October 30, 2015

Re: Hillcrest Country Club Redevelopment, File Number 15-DJP-44
Technical Advisory Committee (T.A.C.) Response Letter

ENTRANCE GATE DETAIL

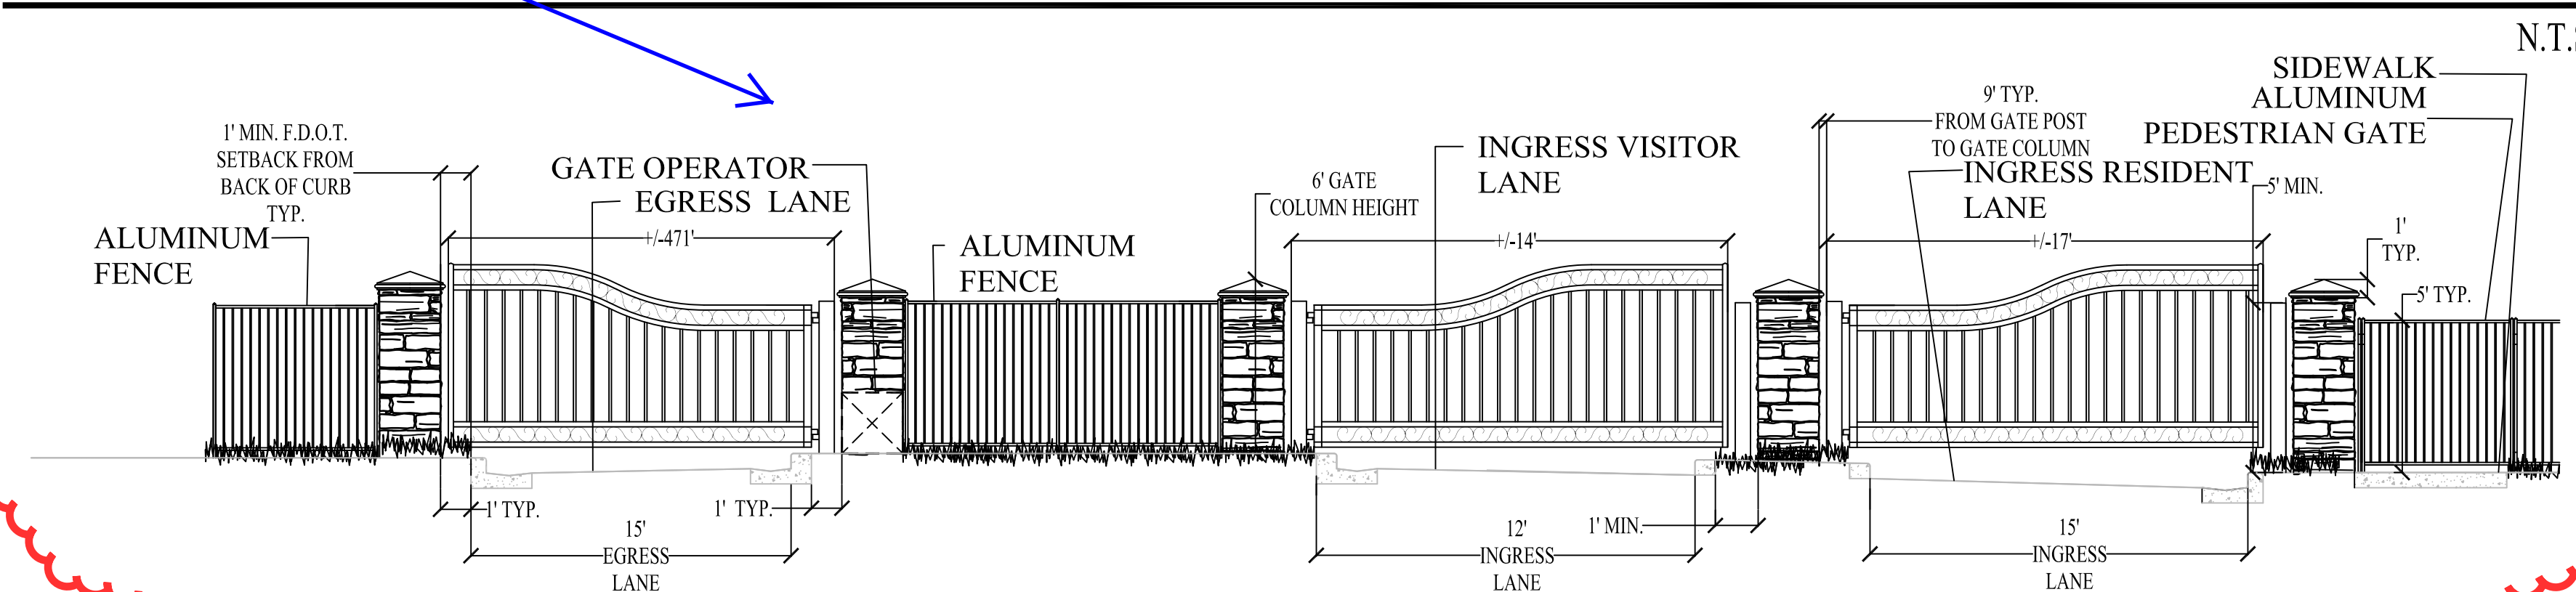
8. Please provide details regarding the entry gate systems for the residents and/or visitors. Please provide a specifications narrative for the gate operations (key fob, call box, etc.) at the identified gated entrances.

Comment J.8

Response: The executive golf course will be accessed utilizing a call box type system. A guest lane will be provided, in which visitors can call the residents for access from the call box. In addition, a resident lane will be provided in which residents will either utilize a clicker type system to allow for access through the vehicular gates or a scanner system in which a bar code is scanned on the residents' vehicle to open the vehicular gates. A Knox box will be provided at the entrance for fire and EMS access. The eighteen hole golf course is proposed to utilize a manned guardhouse, who is available to allow for guests to visit residents. Resident's will utilize the same system as the executive golf course for access; either a clicker system or a bar code scanning system. A Knox box will also be provided for the fire and EMS access into the eighteen hole golf course.

Hydrant with 300' Radius

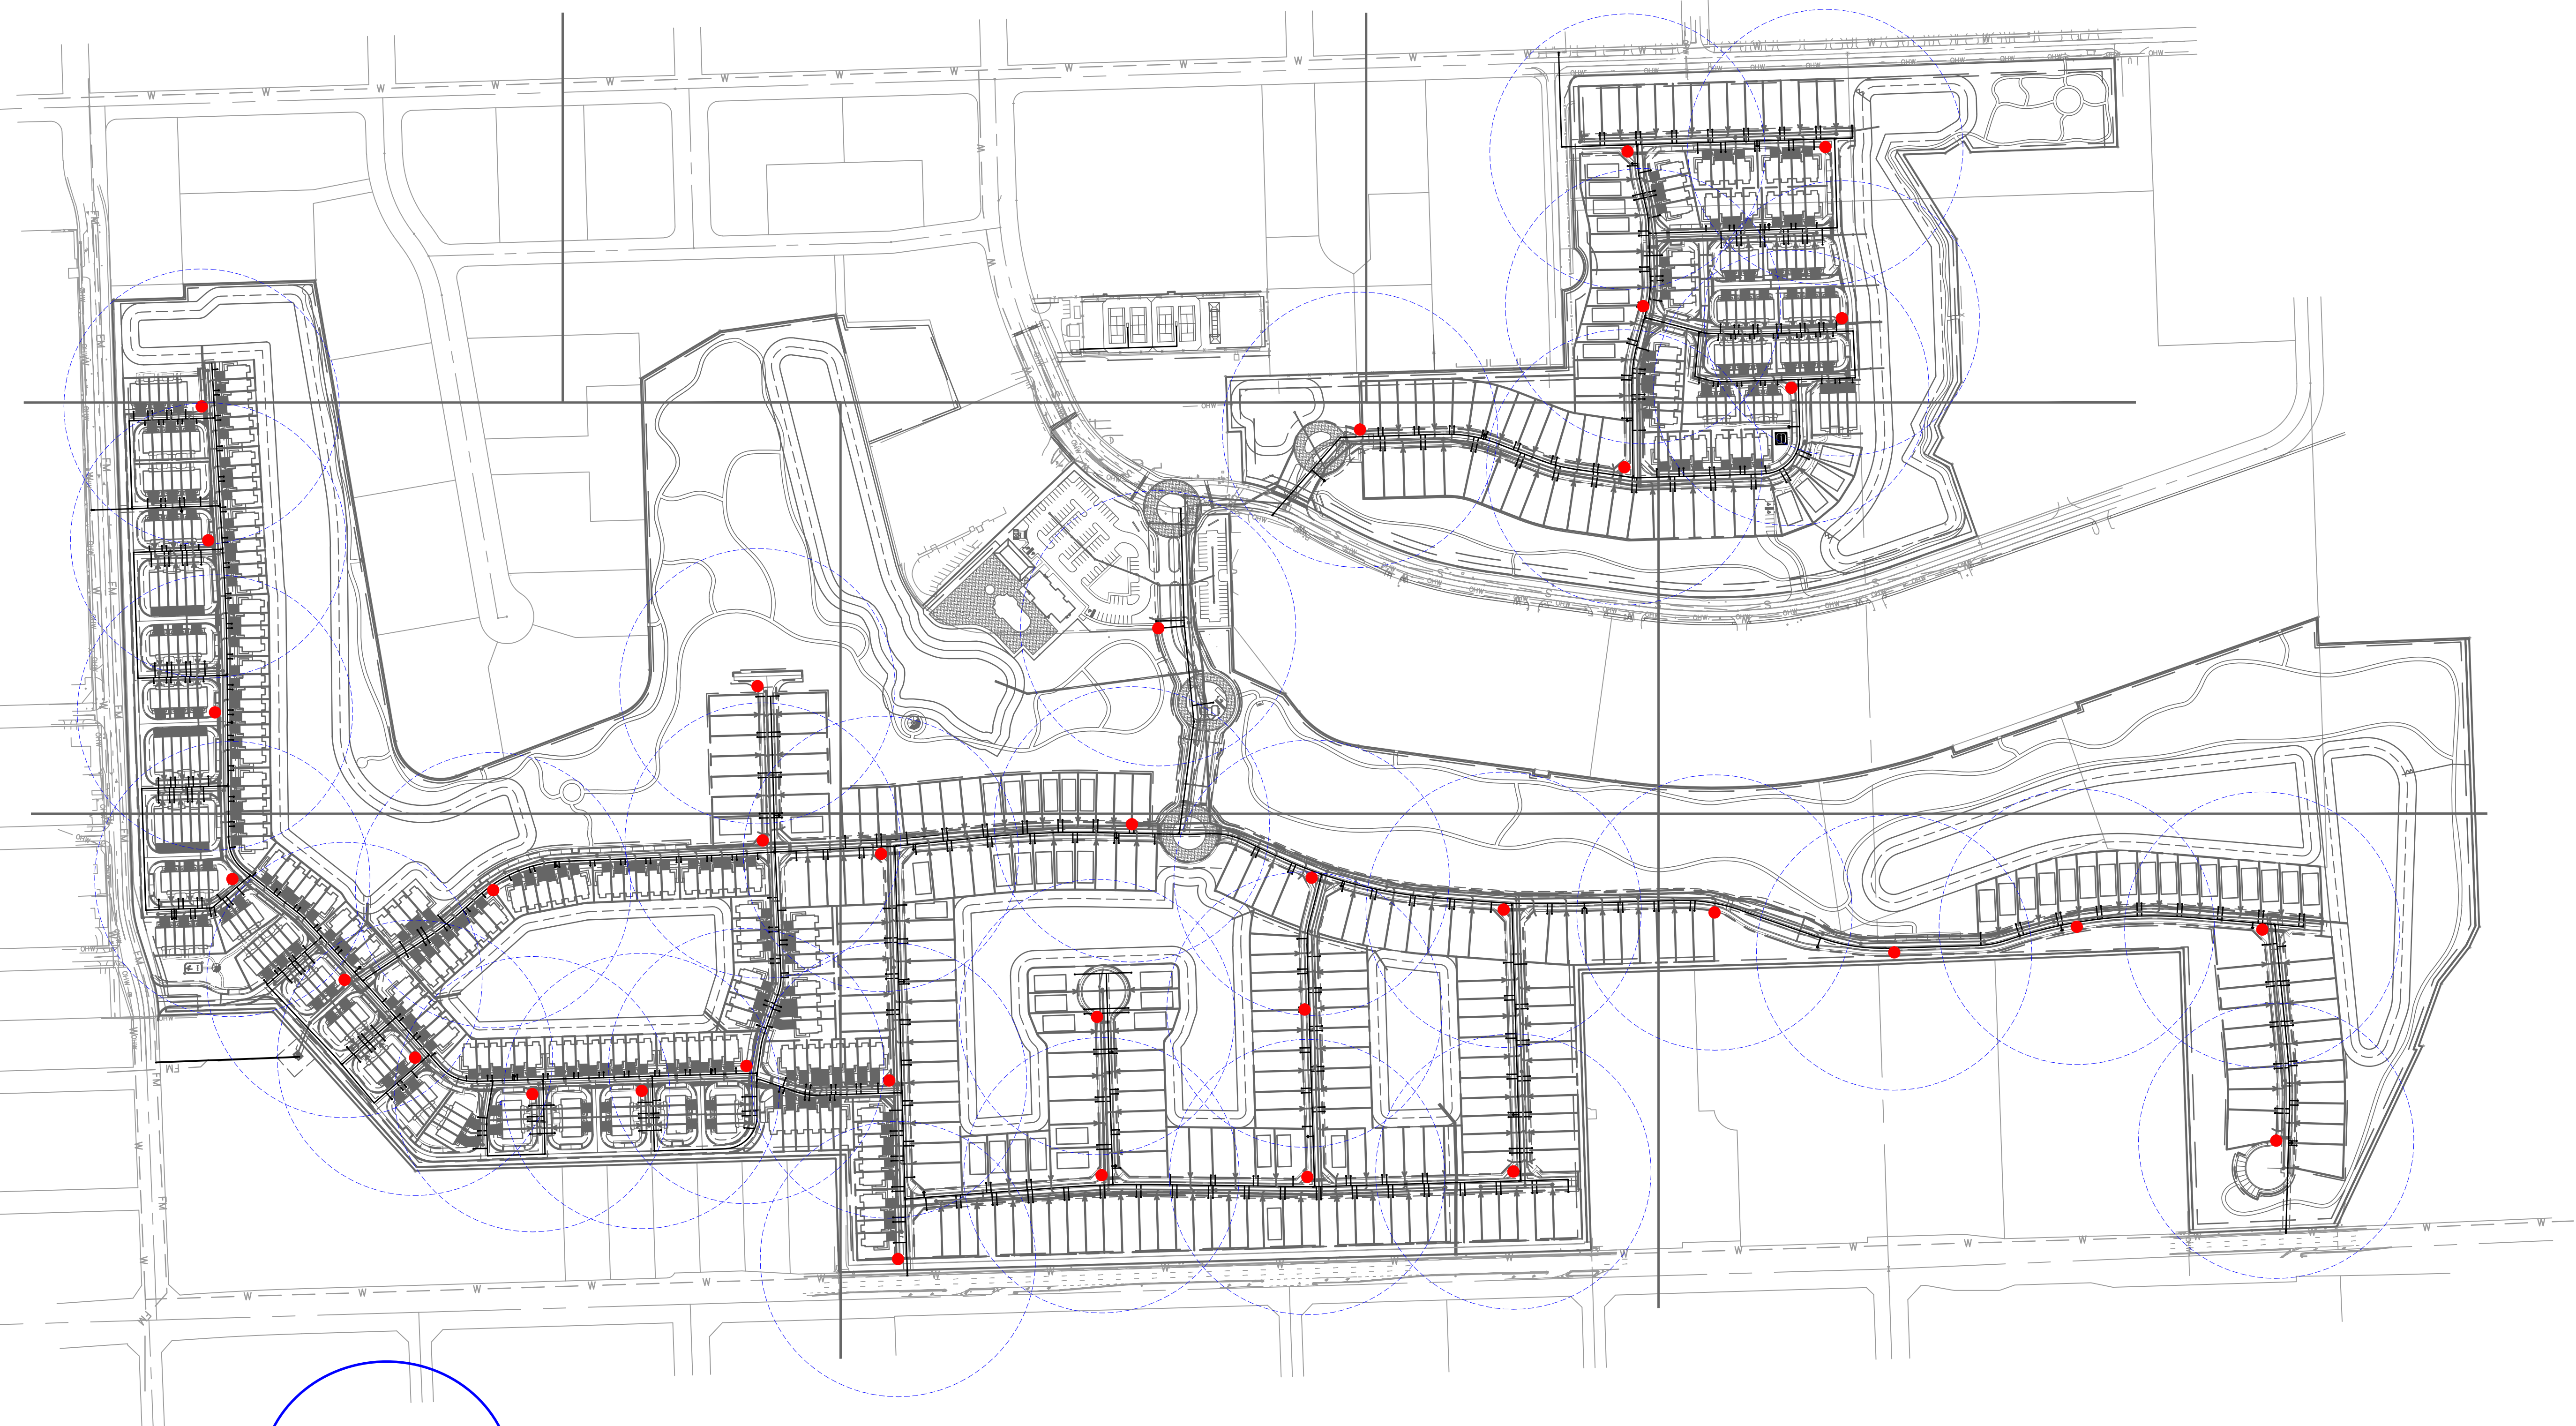
1. Please explain “noted” comment on previous comment #7 on number of hydrants meeting the fire flow requirements found in NFPA 1, 18.4.5.2? When are you planning on determining water supply via a hydrant flow test? Flow test shall be scheduled to determine number of hydrants and water supply shall be installed prior to construction. Although hydrants are shown on C pages, unable to determine if this is sufficient. Reference pages C-303-09.

Comment K.1

Response: A water supply availability report was provided to the Chief of the Fire Department on October 1st, 2015. In addition, a fire hydrant exhibit was also provided to the Chief for review and approval. Fire hydrant locations were revised in order to provide more consistency, from a location perspective, per the request of the Fire Chief. Follow up meetings with Ms. Washburn occurred as well in which it was indicated that the two submitted documents were acceptable. A copy of both documents is included within this resubmittal package.

SECOND FLOOR PLAN
SCALE: 1/4"=1'-0"

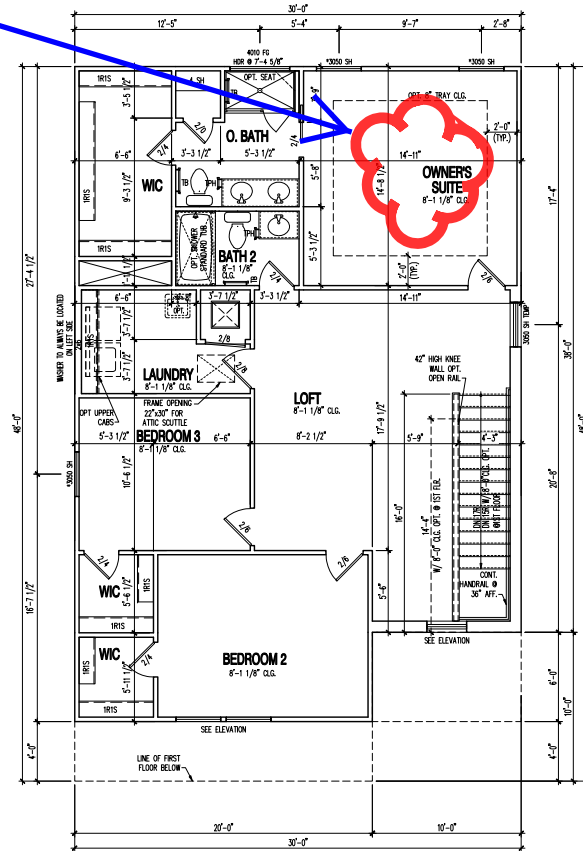
Comment O.5

Response: The dimension to indicate the overall width of 11’-6 ½” has been added to the Park Place Architectural Plans.
